STAFF REPORT
COMMUNITY DEVELOPMENT DEPARTMENT

HEARING DATE: 12/14/2021
 TO: Mayor & City Council
 FROM: Joe Dodson, Associate Planner
 208-884-5533
 SUBJECT: H-2021-0056 & H-2021-0091 (MDA)
 Pera Place Subdivision
 LOCATION: The site is located at 4600 W. Daphne Street, 4546 W. Daphne Street, and Parcel S0427325702, near the northeast corner of N. Black Cat Road and W. McMillan Road, in the NW ¼ & the SW ¼ of the SW ¼ of Section 27, Township 4N., Range 1W.

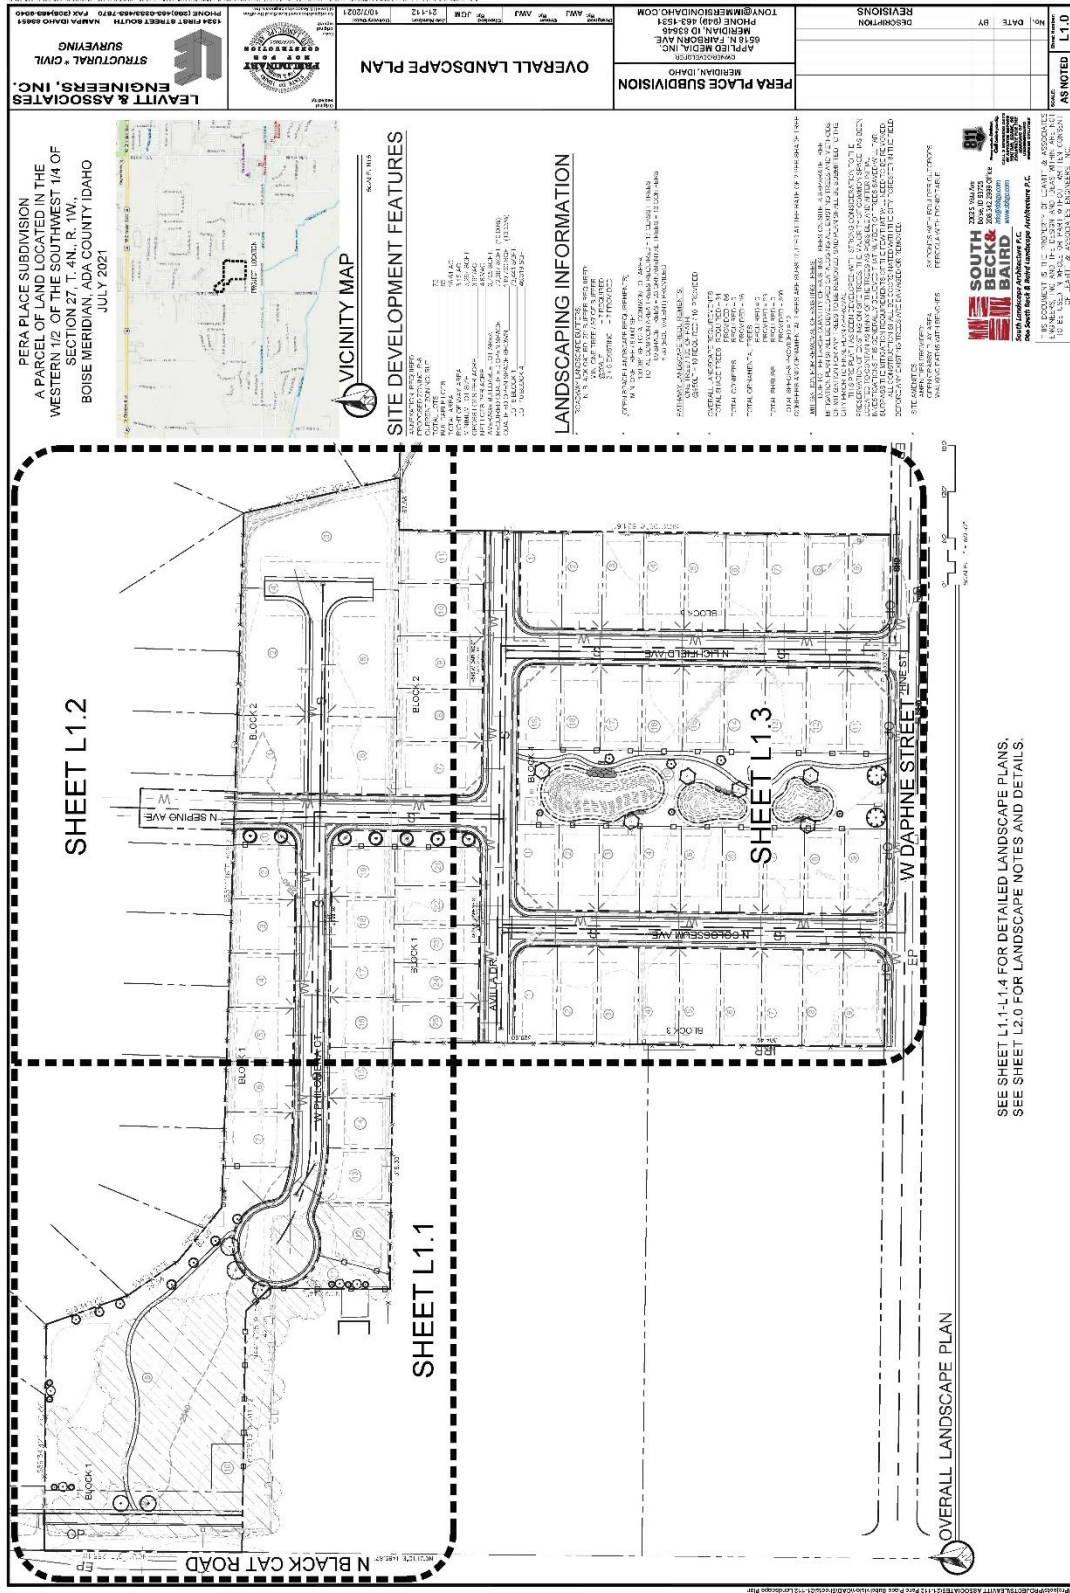
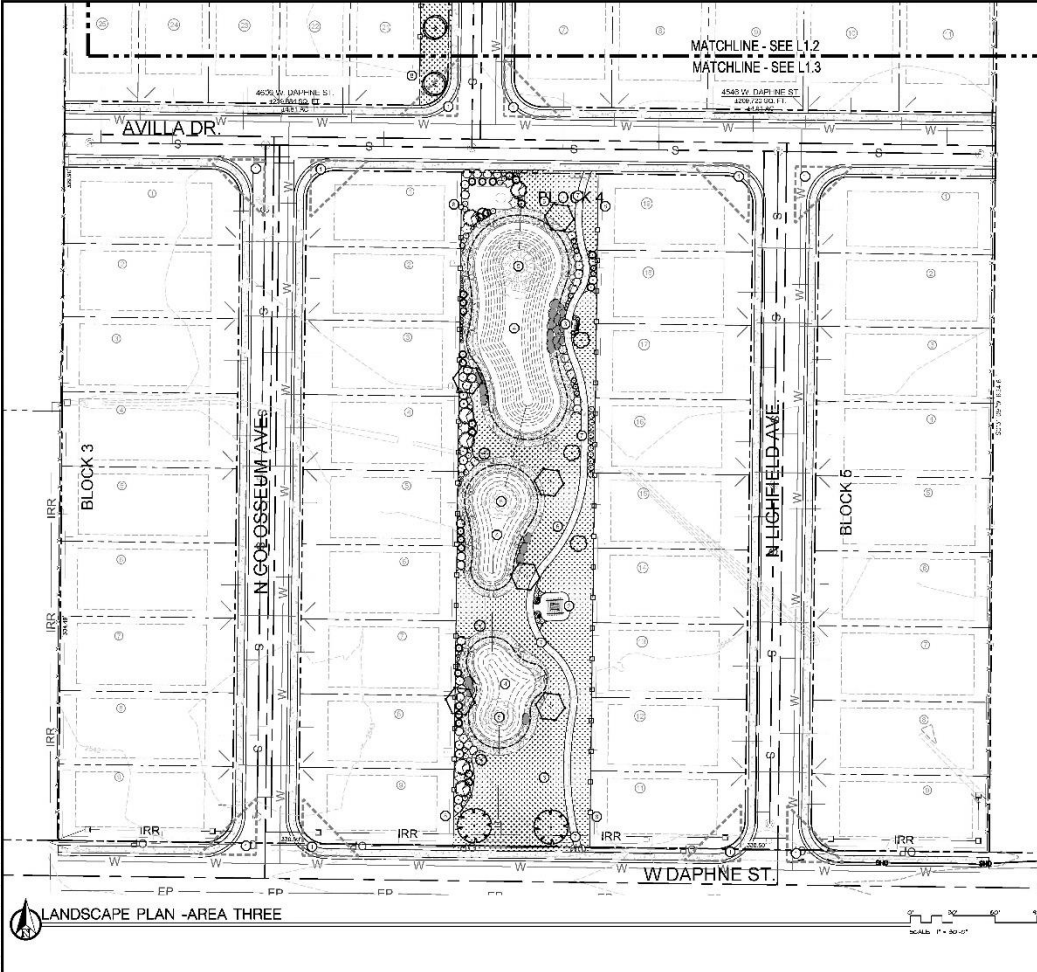
submitted plat, the Applicant has proposed a non-buildable lot over this area. Staff does not support the inclusion of a non-buildable lot for this shared use and instead recommends the developer and the Poorman's enter into a separate agreement that defines how this area is to be used and maintained. This recommendation would remove the non-buildable lot and incorporate this area into the larger common lot as previously proposed by the Applicant. This agreement should be included with a future final plat application and include a termination clause when the Poorman outparcel redevelops or connects to City services.

The residential lots appear to meet all UDC dimensional standards per the submitted plat. In addition, all subdivision developments are also required to comply with Subdivision Design and Improvement Standards (UDC 11-6C-3). *The proposed preliminary plat and submitted plans appear to meet all UDC requirements except for the length of the proposed east-west cul-de-sac shown as W. Philomena Court in the north portion of the site. This cul-de-sac measures approximately 550 feet in length, 50 feet beyond the allowed length by UDC 11-6C-3. Therefore, the Applicant requires a Council Waiver to exceed the 500 foot limit for a dead-end street.*

Off-street parking is required to be provided in accord with the standards listed in [UDC Table 11-3C-6](#) for single-family dwellings based on the number of bedrooms per unit. Staff will confirm compliance with these standards at the time of building permit submittal for each residence. In addition, the proposed 33-foot wide street section accommodates on-street parking where no driveways exist. Furthermore, no on-street parking is allowed within any part of the cul-de-sac at the end of W. Philomena Court unless the Applicant revises it to be constructed with a 57-foot radius.

As noted above, the Applicant is proposing a micro-pathway from the cul-de-sac to the detached sidewalk along Black Cat through the existing tree area. Because this area is densely vegetated and has a relatively large gap between any roads (approximately 400 feet of micro-path), Staff is concerned with safety while traversing this path. Staff is unaware if these trees are pruned to accommodate better visibility or the level of visibility between the proposed cul-de-sac and Black Cat. Therefore, Staff is including a DA provision to install and maintain lights along this micro-path to help with pedestrian safety and meet CPTED policies in this area.

3. The revised preliminary plat included in Section VII.B, dated September 17, 2021, shall be revised as follows prior to submitting for Final Plat approval:

- a. Add a plat note stating that direct lot access to N. Black Cat Road is prohibited.
 - b. Remove the non-buildable lot (Lot 10, Block 1) for the Poorman outparcel septic drain field and show it as part of the larger common lot (Lot 8, Block 1).

AS NOTED L1.3

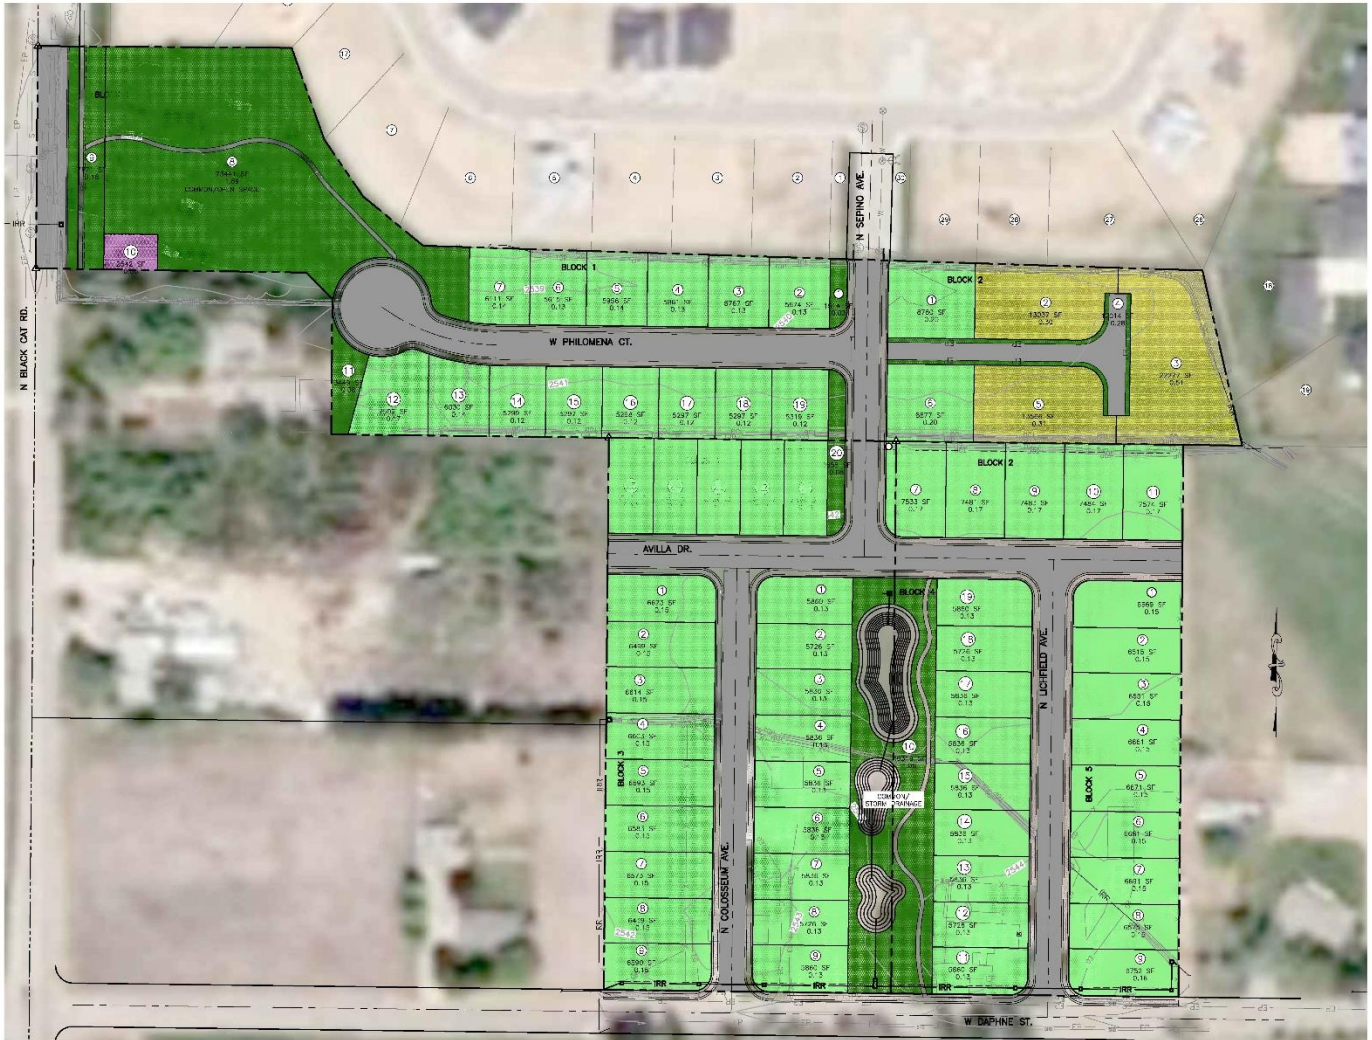
The Applicant is required to dedicate additional right-of-way for Black Cat total 50 feet from centerline. This additional dedication is for future widening of Black Cat but in the meantime, UDC 11-3B-7C.5 requires a gravel shoulder of no more than 10 feet with the remaining area to be vegetated with lawn or other vegetative ground cover; gravel is not a sufficient ground cover material. According to the submitted landscape plans, the Applicant is not showing compliance with this code section. So, Staff is recommending a condition of approval to revise the landscape plans to meet this requirement prior to Final Plat submittal.

4. The landscape plan included in Section VII.C, dated October 7, 2021, shall be revised as follows prior to submitting for Final Plat approval:
 - a. Any landscaping within the ACHD right-of-way shall be landscaped in accord with UDC 11-3B-7C.5.
